**Shrewsbury West Sustainable Urban Extension - Welshpool
Road**

Transport Issues Technical Note

**Shropshire Council
October 2010**

Appendix A - Assessment of Five Arm Roundabout Option for Churncote Island junction

Drawing Number: 1023131-P-030
 Revision: C

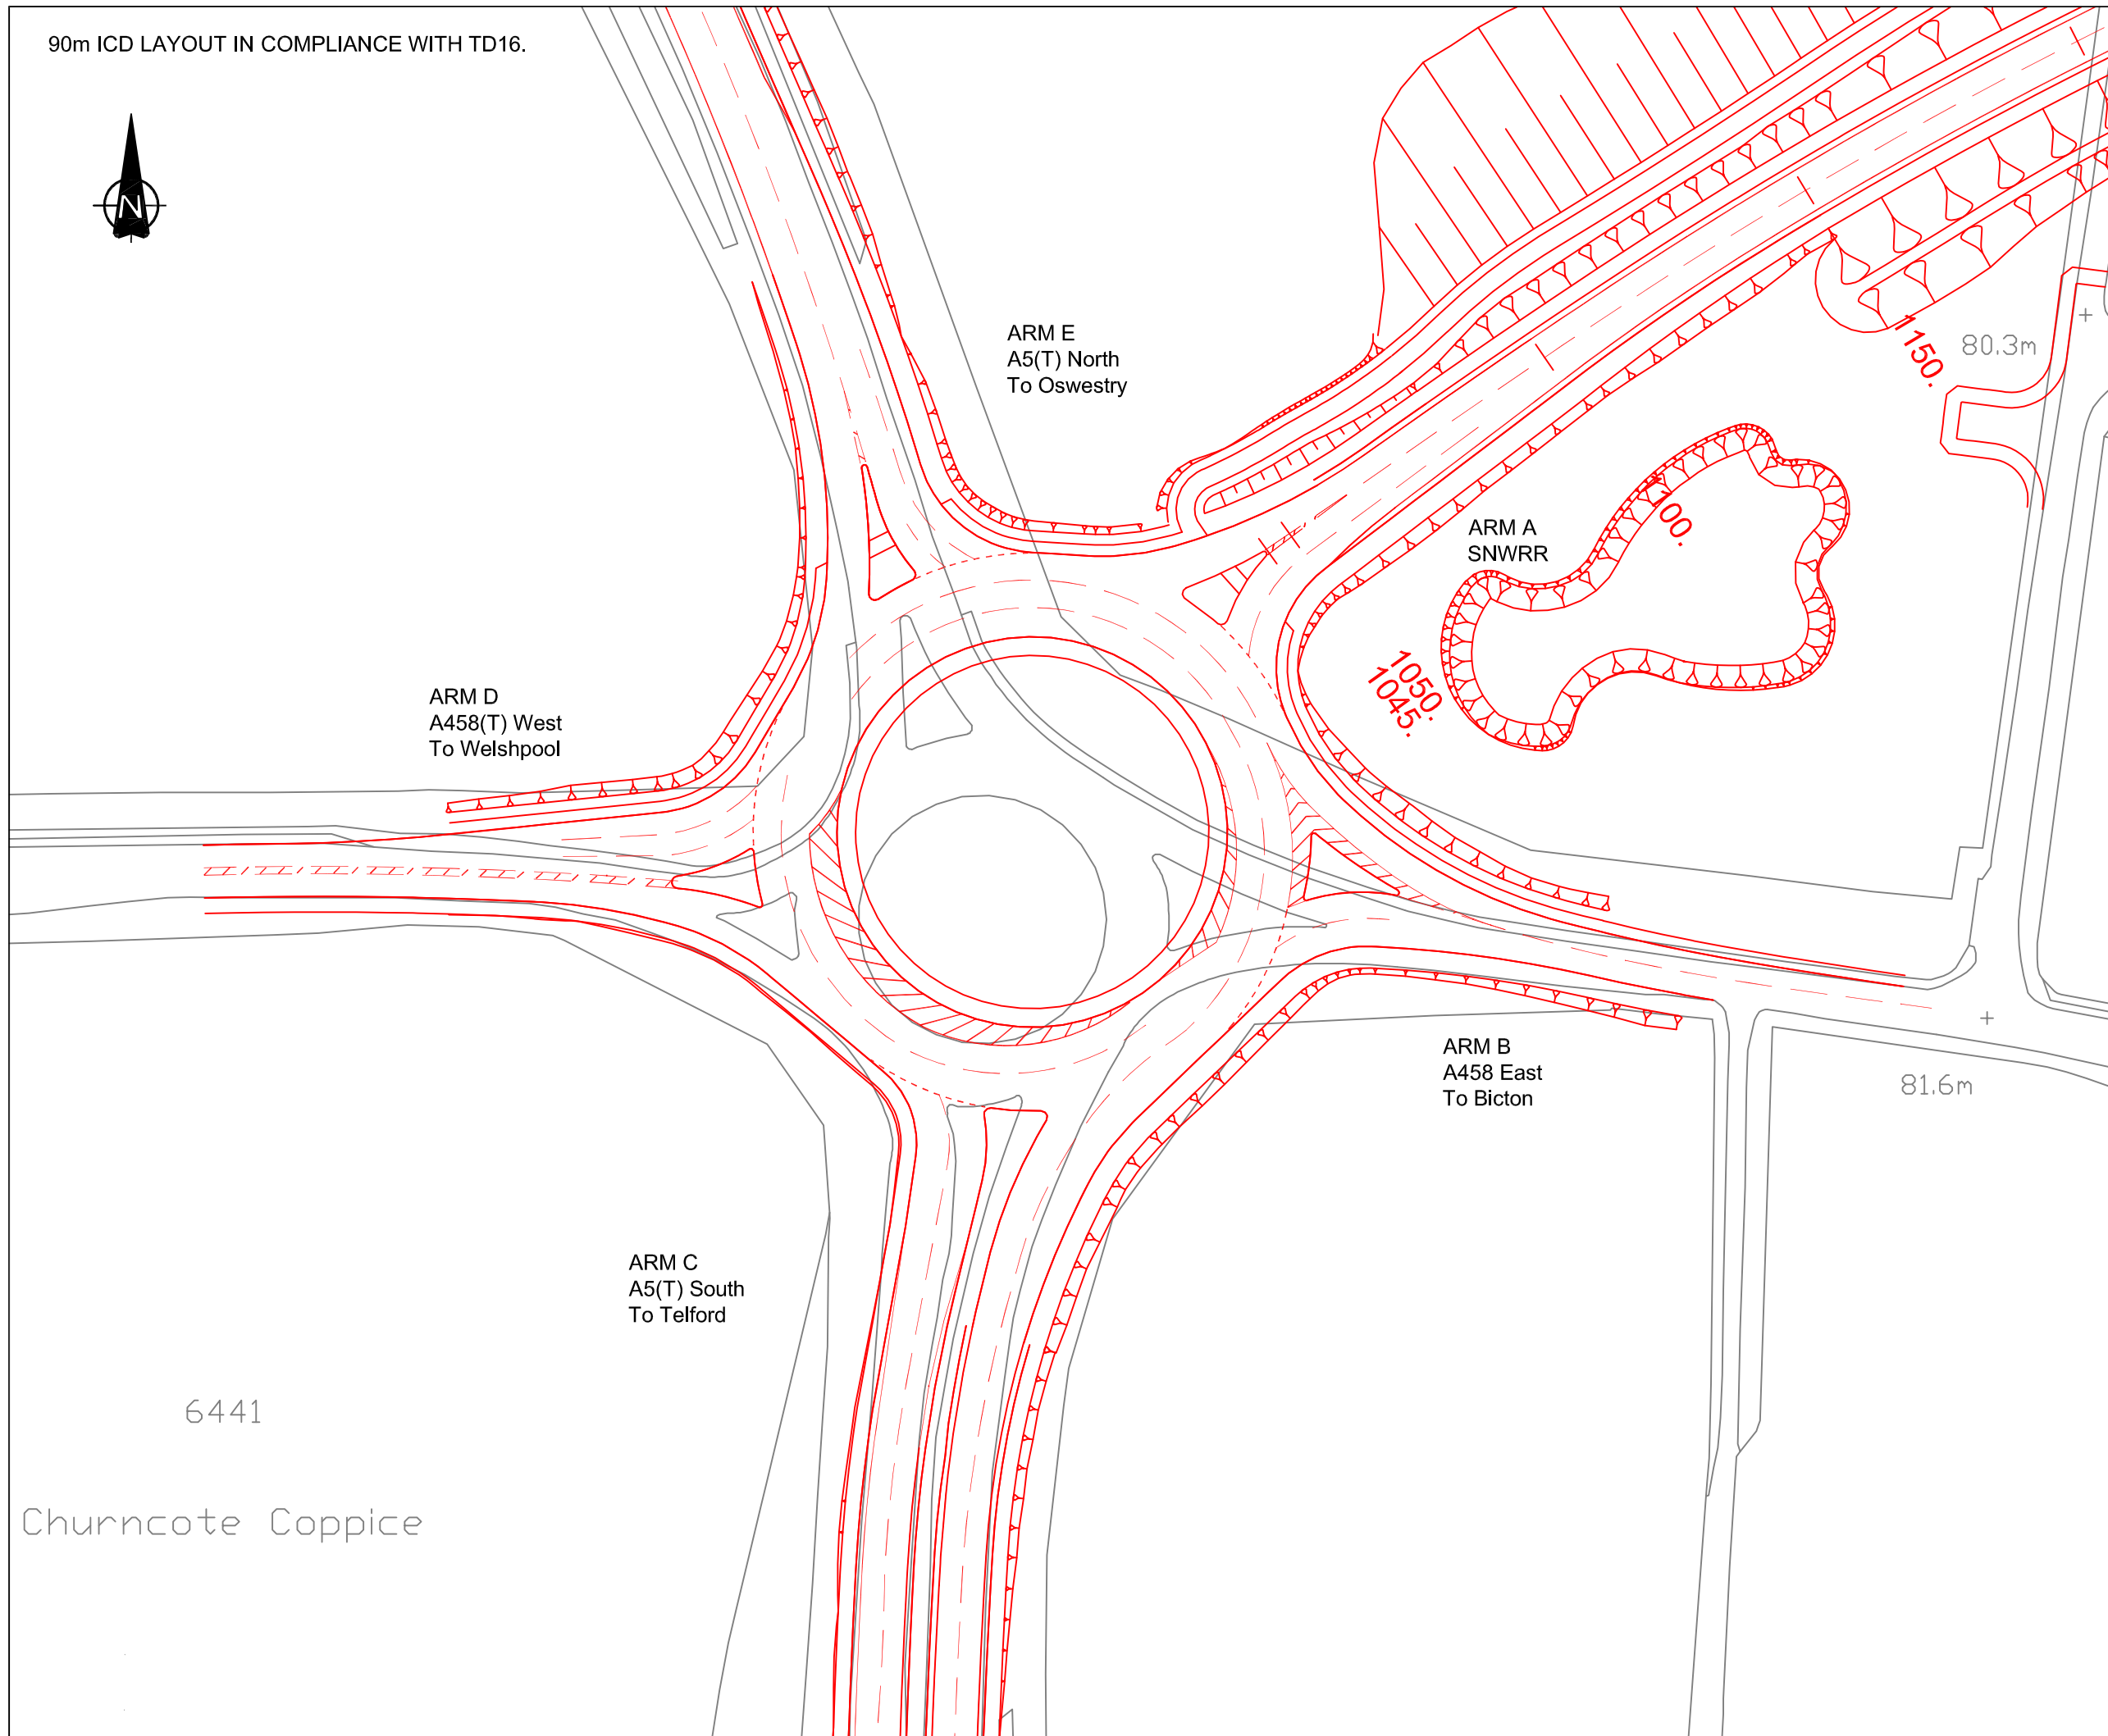
The report was submitted on behalf of Shropshire County Council in support of proposals for the development of the Shrewsbury North West Relief Road (SNWRR). The specific focus of the report is to provide modelling evidence to support alterations to the existing A5/ A458 'Churncote' Roundabout to entail increasing the footprint of the junction up to 90m ICD and provision of an additional 5th arm approach to the circulatory to provide a direct link between the A5 and SNWRR.

As shown above, there are differences between the two sets of modelling outputs. In respect of the Highways principle concerns, the revised modelling undertaken by JMP appears to demonstrate that the two A5 approaches to the junction (arms B & D) operate in excess of the theoretical threshold of 0.85 RFC, albeit with relatively limited levels of queuing. It should also be recognised that this represents there is considerable amount of benefit from the junction improvement proposal when compared against the 'Do Minimum' option testing.
